# Addendum Addenda

No./No  2
-----------------

Project Description / Description de projet <b>U-61 Asbestos Containing Fireproofing Removal and Cladding Replacement</b>		
Project No./No de projet <b>5698</b>	Departmental Representative / représentant ministériel <b>Benoit Huot</b>	Date <b>15 Dec 2020</b>
Solicitation No./N° de sollicitation <b>20-58082</b>		
Notice: This addendum shall form part of the tender documents and all conditions shall apply and be read in conjunction with the original plans and specifications.		
Nota: Cet addenda fait partie intégrale des dossiers d'appel; toutes les conditions énoncées doivent être lues et appliquées en conjonction avec les plans et les devis originaux.

PROJECT: PROJECT NO. = 5698  
BUILDING U-61 (UPLANDS CAMPUS)  
**U-61 EXTERIOR UPGRADES OF UPPER TARMAC CLADDING COMPLETE WITH FIREPROOFING ABATEMENT**

20 REAR PARAPET AT VERTICAL BAY DOOR  
 A09 1:5 SECTION VIEW

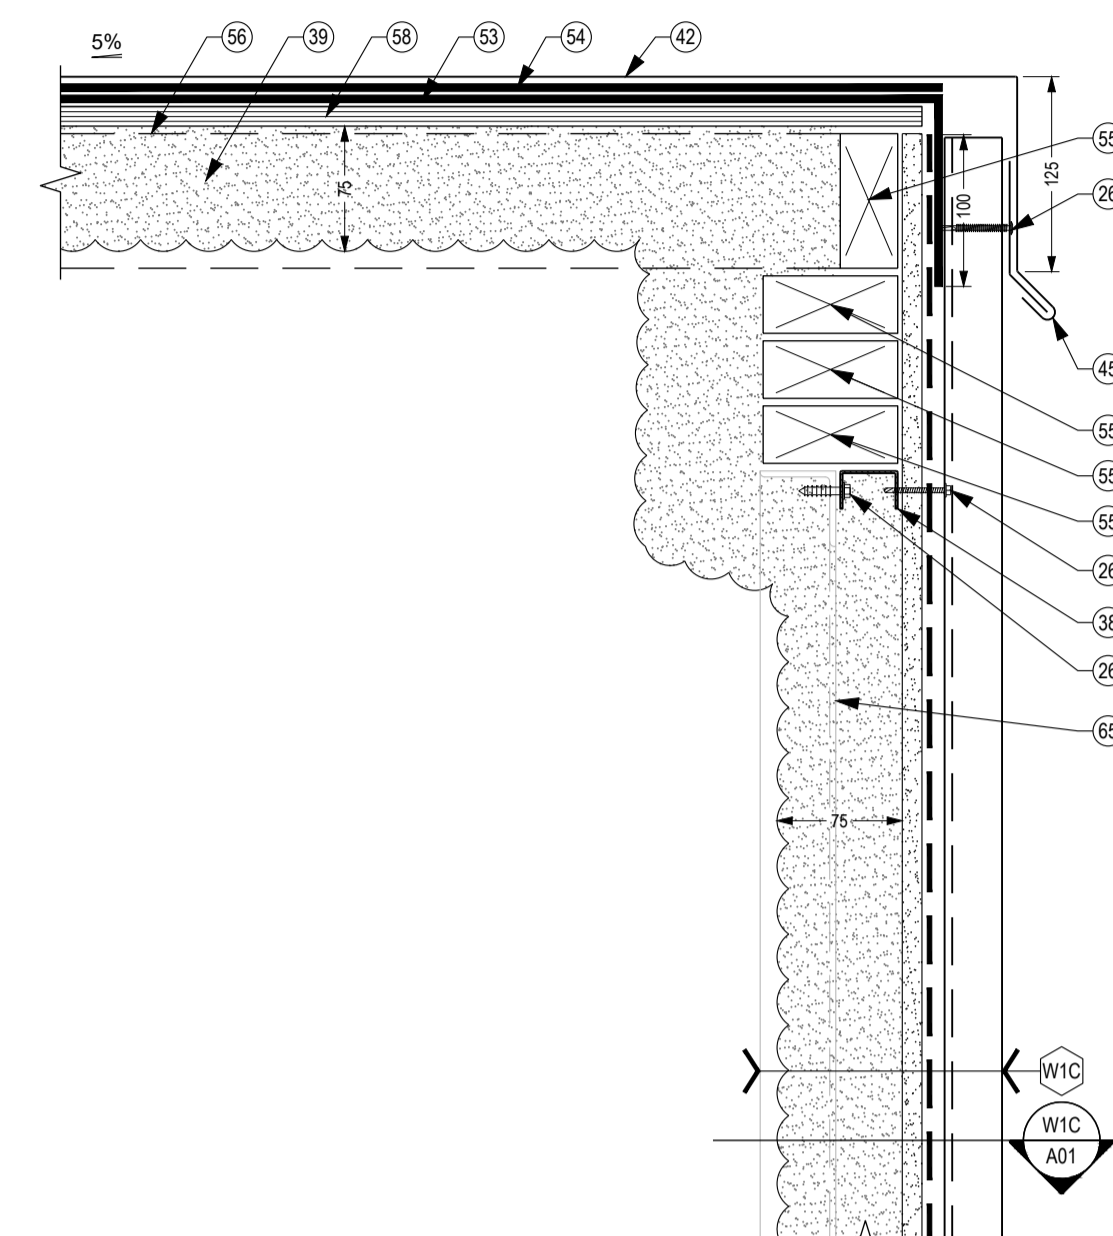
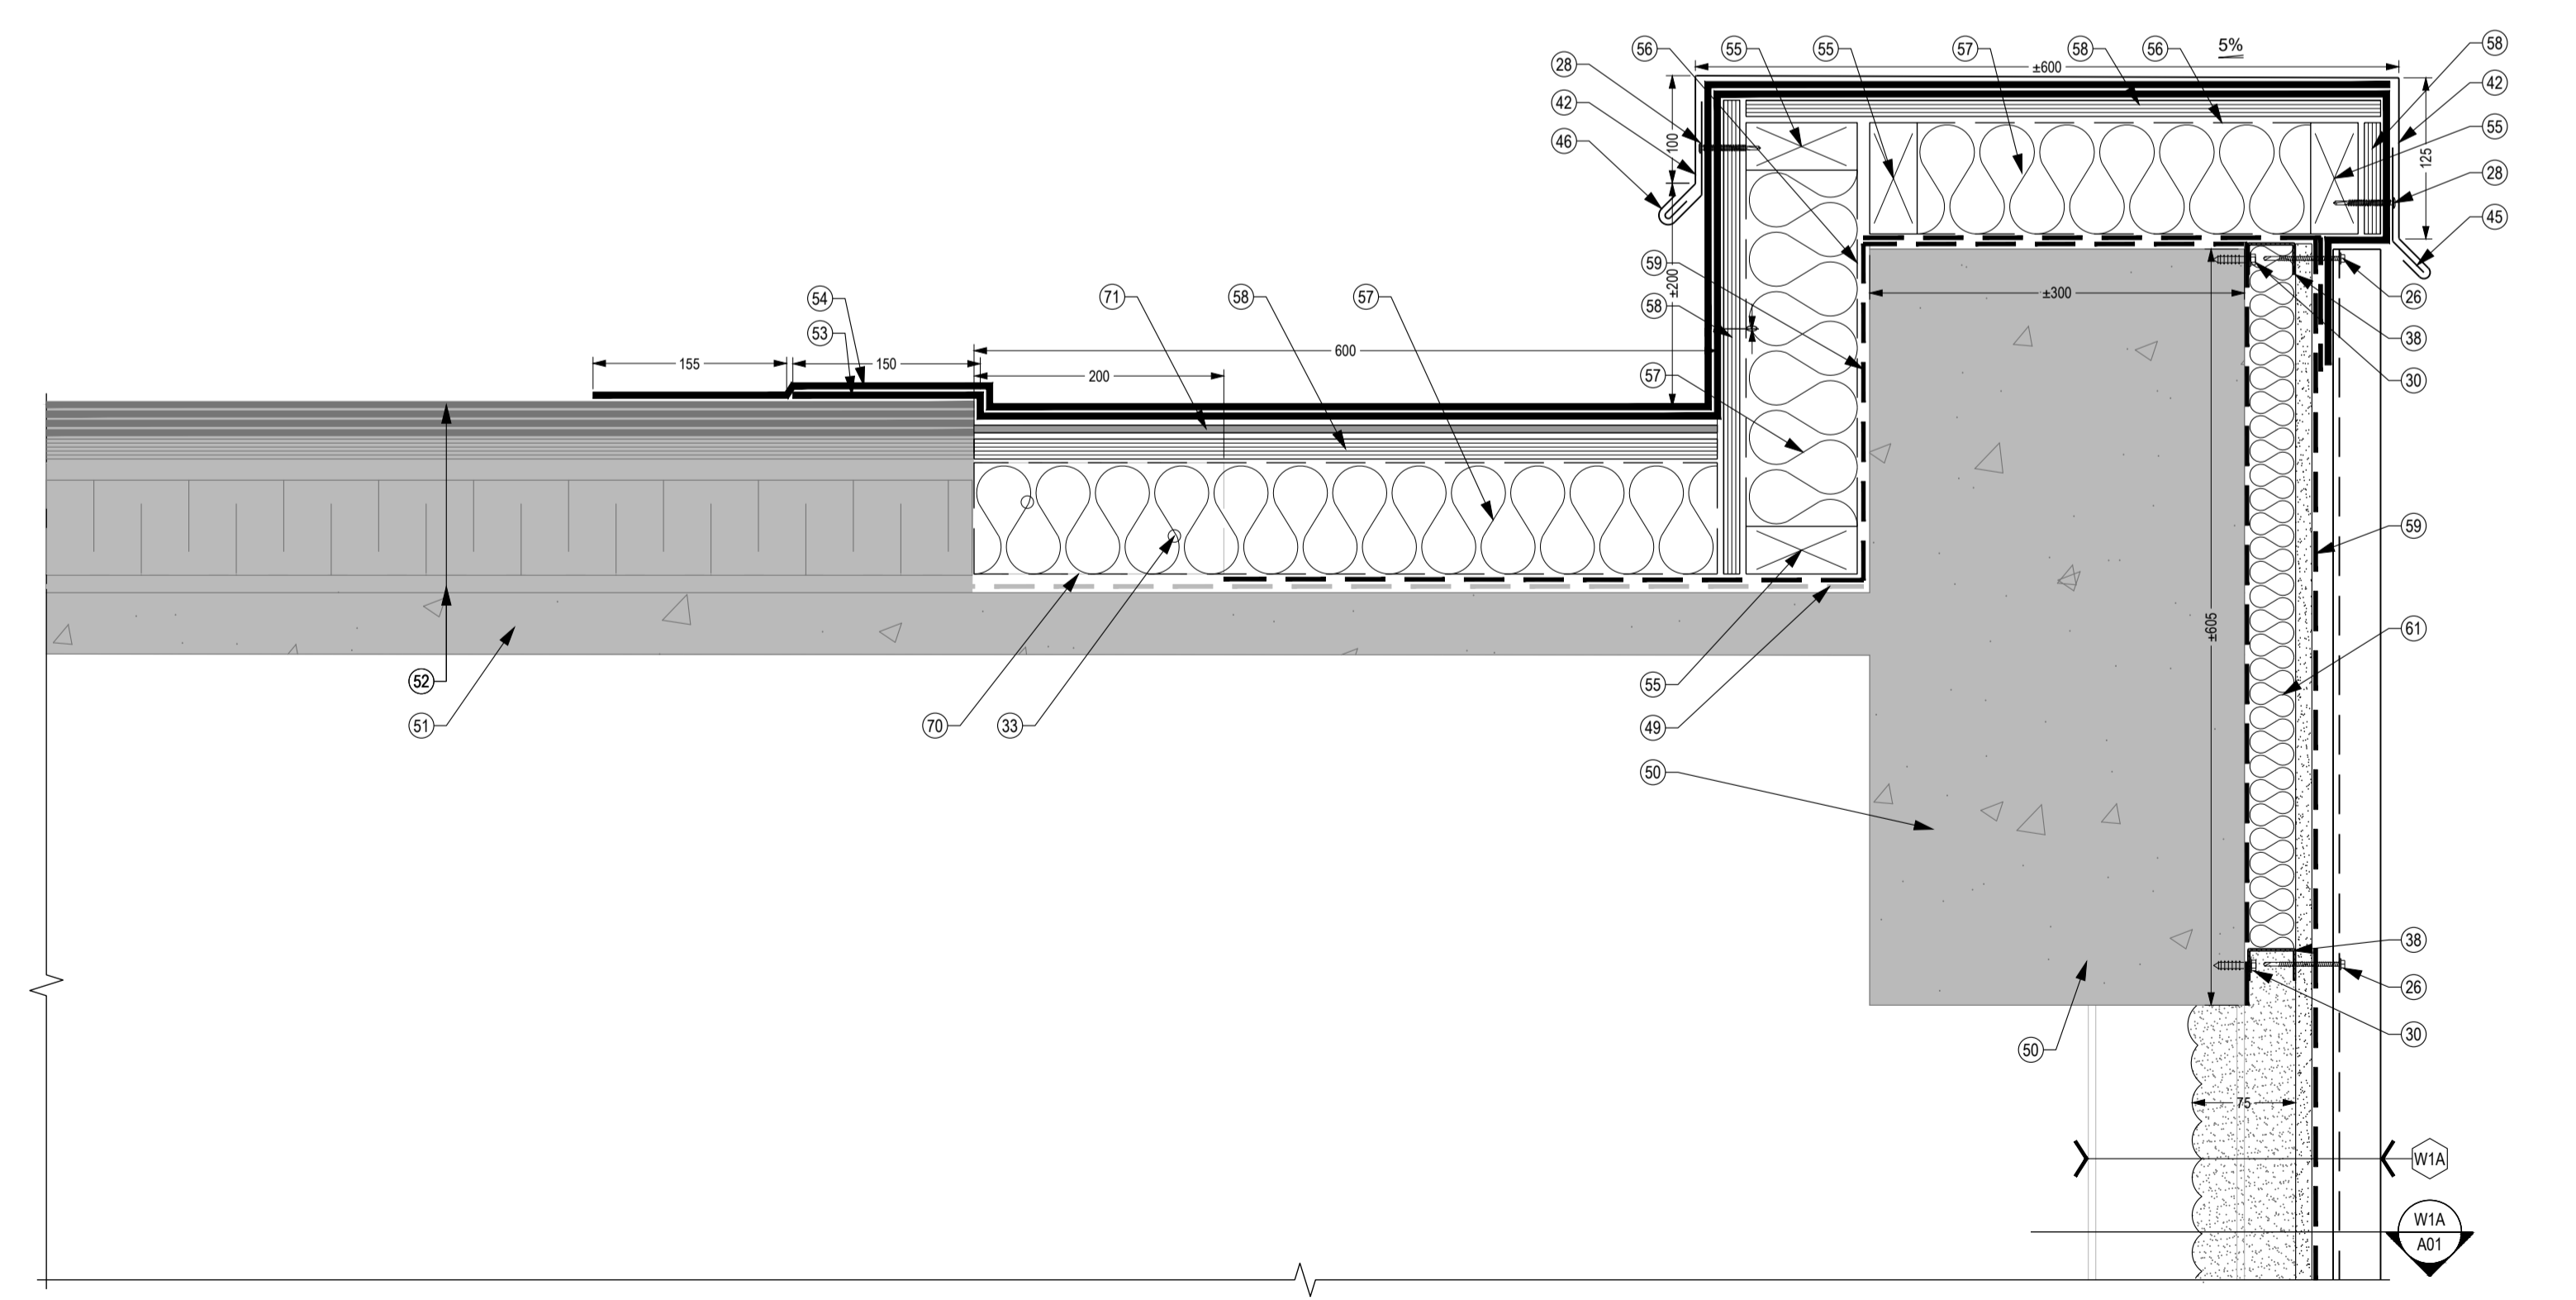
Architectural note 56 indicates 38x89 wood but detail 20 & 21 A9 has arrow pointing at dashed line. Please Clarify

The dashed line indicates that there is a stud support assembly at this location. Note 56 is correct and reads: "38 mm x 89 mm WOOD STUDS @ 400 mm C/C."

38 LATERAL ROOF TIE-IN TO CONCRETE  
 A12 1:5 SECTION VIEW

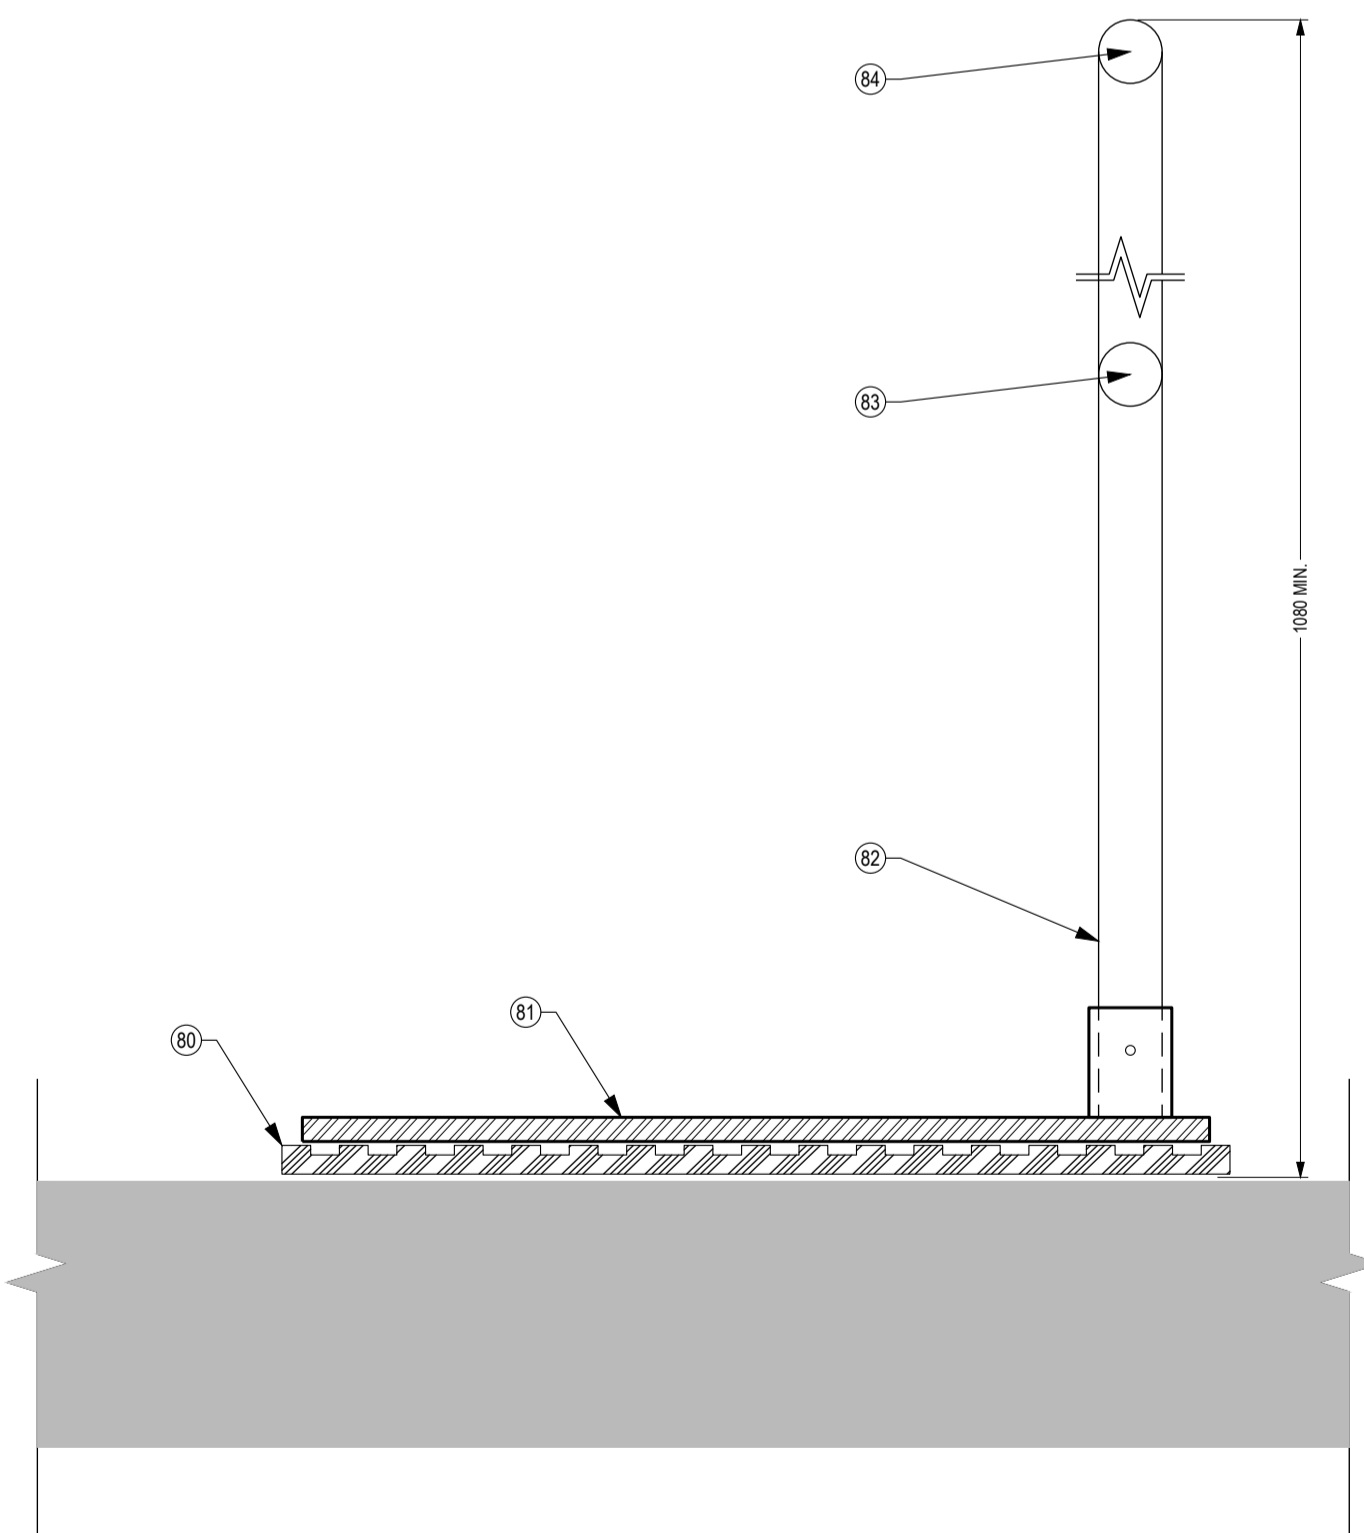
Architectural detail 38A12 notes relet cut into existing concrete wall at standing Seam roof. Cross sections 16 & 17 A08 show steel cladding on concrete walls. Please Clarify if cladding to be installed over wall flashing /reglet tie in as not show on detail 38.

There is no metal cladding to be installed over the concrete walls. Sections 16 & 17 cut lines on Detail 15/A08 have been revised. Sections 16 & 17 show the cladding present on the sides of the central portion of the hanger.
